McCULLOCH CORPORATION
SERVICE BULLETIN

1557

MODEL: Mini-Mac 1, 1A, 6, 6A, 30, & 35

SUBJECT: Use of Oil Plate, PN 90654

Figure 1. Long and Short Oil Troughs (Shaded Areas) in Bar Pads.

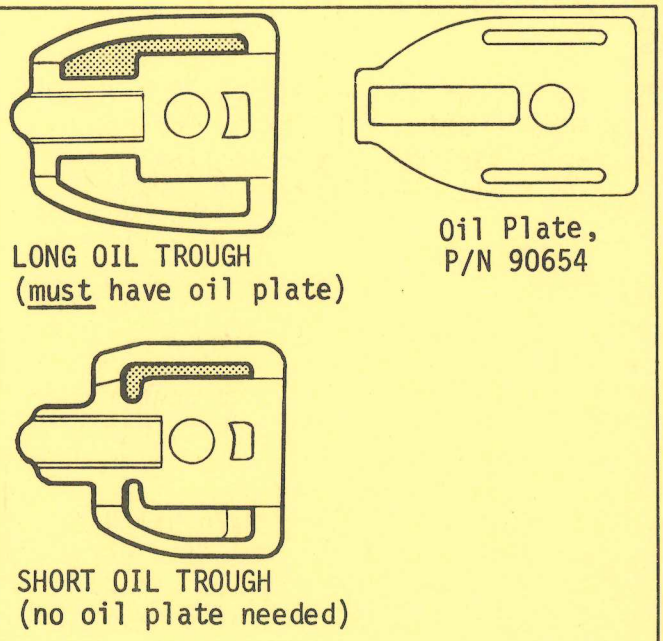
When bars in Table 1 are used on any Mini-Mac 1, 1A, 6, or 6A, or early models of the Mini-Mac 30 or 35 (which have a long oil trough shown in Figure 1), Oil Plate, PN 90654, must be used to prevent oil escape from the rear of the oil trough when the bar is moved out to its maximum adjustment. To ensure proper chain and bar lubrication, put the oil plate between the bar pad and the bar, as shown in Figure 2.
